Model: PRIPORT TITANIUM2		Date: 05-Jul-06	No: M-C261-001
Modified Article: VC-20 COMPONENT PARTS		Prepared by: M. Kanomata	
From: Priport Service Planning Section			
Classification: ☐ Parts catalog correction ☐ Vendor change ☐ To meet standards ☐ To facilitate assembly ☐ To improve reliability () ☐ Part standardization ☒ Other ()			
Model Name: Ricoh JP735/JP755/JP785C, Gestetner 6123a+/6123b+/6123L+/6200C, Lanier LDD 735, nashuatec 6123a+/6123b+, RexRotary 6123a+/6123b+

Model: PRIPORT TITANIUM2		Date: 3-Oct-06	No: M-C261-002
Modified Article: Parts catalog correction for VC-20		Prepared by: K. Yamamoto	
From: Priport Service Planning Section			
Classification: ☒ Parts catalog correction ☐ Vendor change ☐ To meet standards ☐ To facilitate assembly ☐ To improve reliability () ☐ Part standardization ☐ Other ()			
Model Name: Ricoh JP735/JP755/JP785C, Gestetner 6123a+/6123b+/6123L+/6200C, Lanier LDD 735, nashuatec 6123a+/6123b+, RexRotary 6123a+/6123b+

Model: PRIPORT TITANIUM2		Date: 12-Jun-07	No: M-C261-004
Modified Article: PSU		Prepared by: M. Kanomata	
From: Priport Service Planning Section			
Classification: ☐ Parts catalog correction ☐ Vendor change ☐ To meet standards ☐ To fa

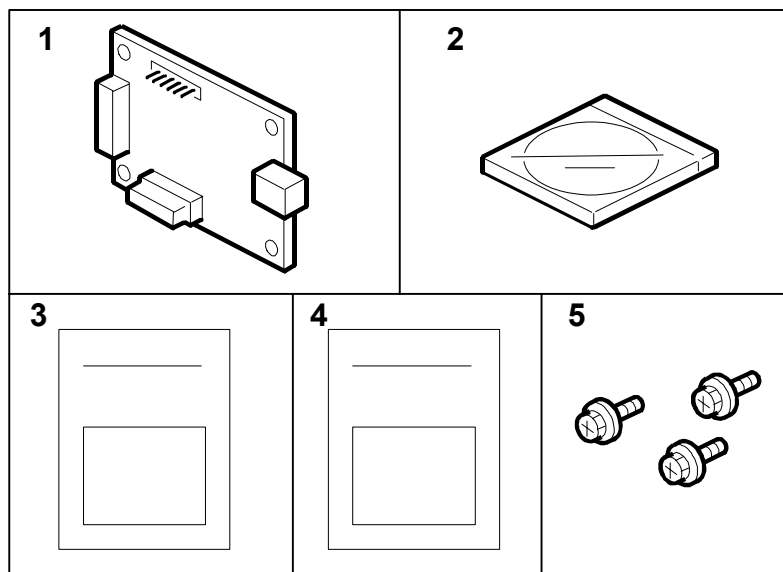
Index	Old #	New #	Description	Q'ty
1	C6465000	C6465010	CONTROL BOARD UC-2 ASS'Y	1

Change: The controller board was changed.

Reason: To support the Japanese display language.

10.DRUM UNIT 1 (C261)

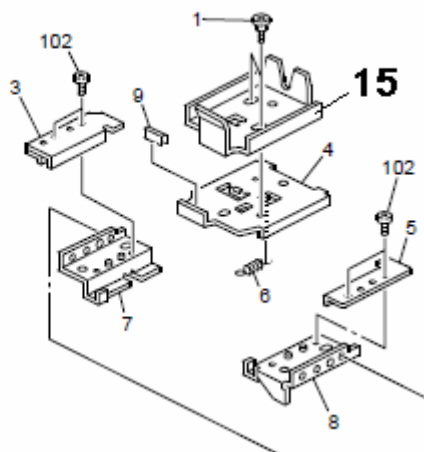
Change/Reason: This part was missing from the Parts Catalog.

PN	Description	Qty	Page	Index
C2522550	Holder: Ink Cartridge	1	25	15

3. SCANNER SECTION (Index 13)

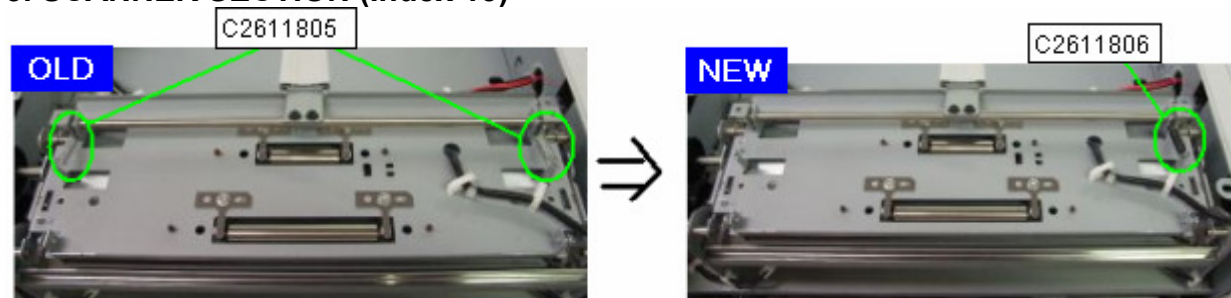
Old part number	New part number	Description	Q'ty	Int	Page	Index
C2611805	C2611806	TENSION SPRING:GRIP:OPEN AND CLOSE	2->1	X/O	11	13
C2611056	C2611995	STAY:INNER BACK:MAIN ASS'Y:PLOTTER	1	X/O	17	1*
	C2611996	STAY:FRONT:MAIN ASS'Y:PLOTTER	1	as a set	17	1*

- 1) One of the two springs was deleted.
- 2) The remaining spring (C2611805) was changed to a stronger one.
- 3) The stay (**upper side only**) was separated into two pieces.

Reason: To strengthen the mechanisms which use these parts.

6. PAPER FEED SECTION (Index 1)

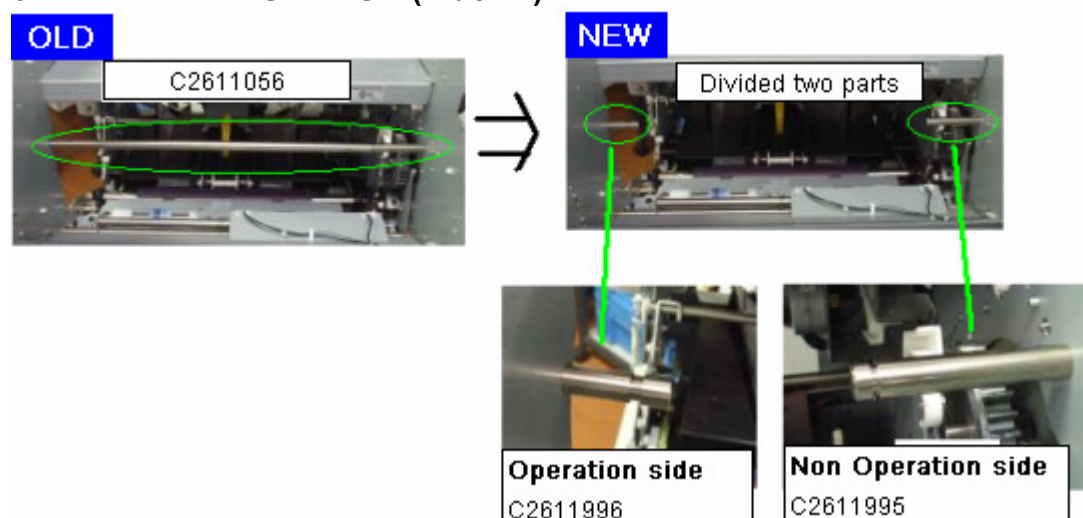
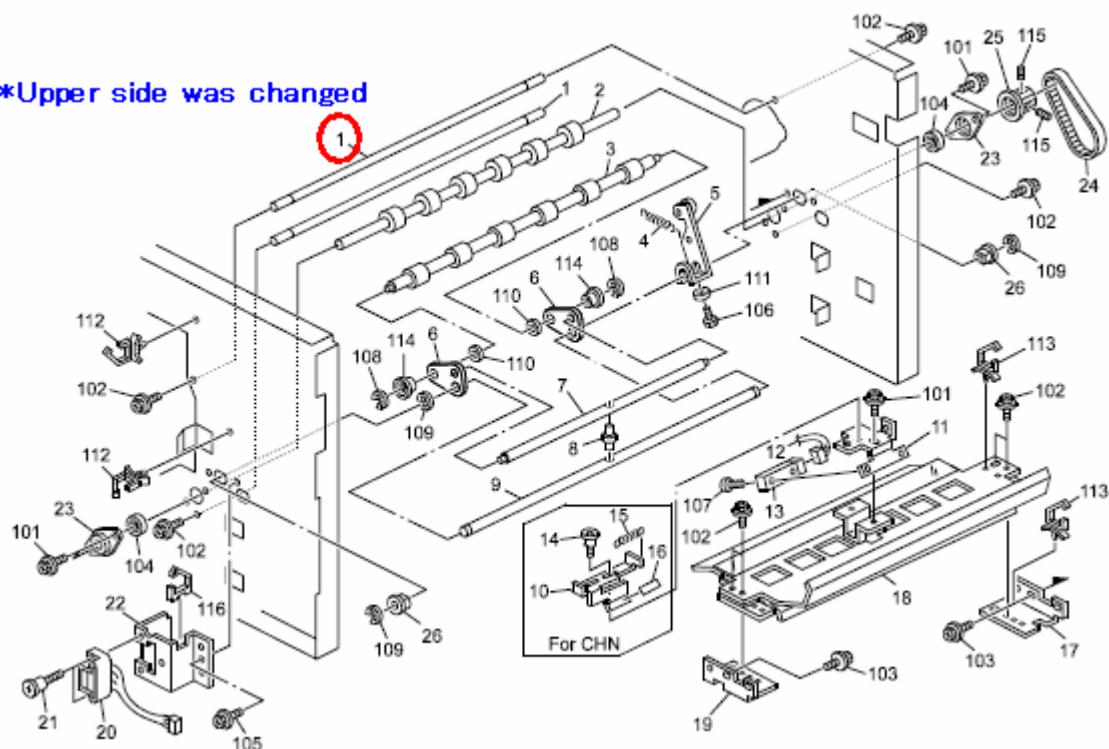
*Upper side was changed

17. DRIVE AND FRAME SECTION

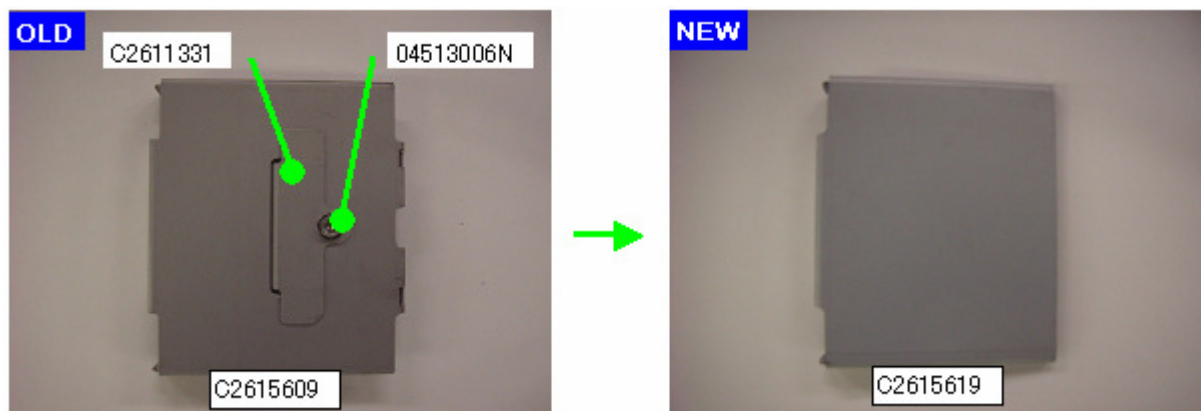
Old part number	New part number	Description	Q'ty	Int	Page	Index
C2615609	C2615619	BRACKET:COVER:FIX	1	O/O	39	17
C2611331	-	CAP:CONTROL BOARD	1	X/O	39	18
04513006N	-	TAPPING SCREW - 3X6	1	X/O	39	103

Change: The cap and screw were deleted.

Reason: To facilitate assembly.

1. EXTERIOR

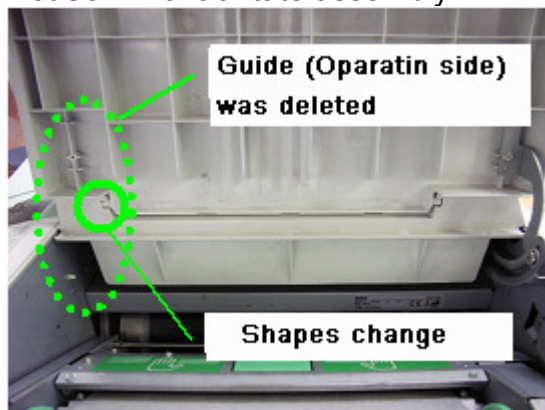
Old part number	New part number	Description	Q'ty	Int	Page	Index
C2521304	C2611304	COVER:PLOTTER	1	O/O	7	15
C2611321	-	GUIDE:FRONT:COVER:PLOTTER	1	X/O	7	18

Change: The guide was deleted.

Reason: To facilitate assembly.

13. VACUUME FAN UNIT

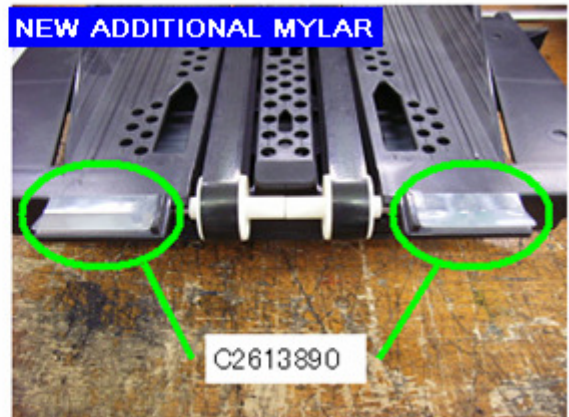
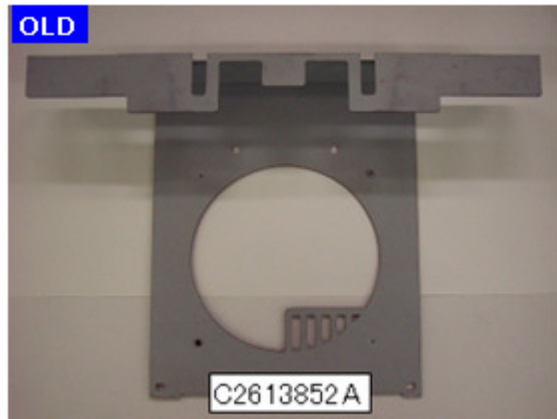
Old part number	New part number	Description	Q'ty	Int	Page	Index
C2673802	C2673803	HALE UNIT:ASS'Y	1	O/O	31	*
C2613852	C2613853	BRACKET:FAN:HALE UNIT	1	X/O	31	10
	C2613890	GUIDE:HALE UNIT	2	as a set	31	new

Change: The shape of the bracket was changed and the Mylars were added.

Reason: To further improve paper transport.
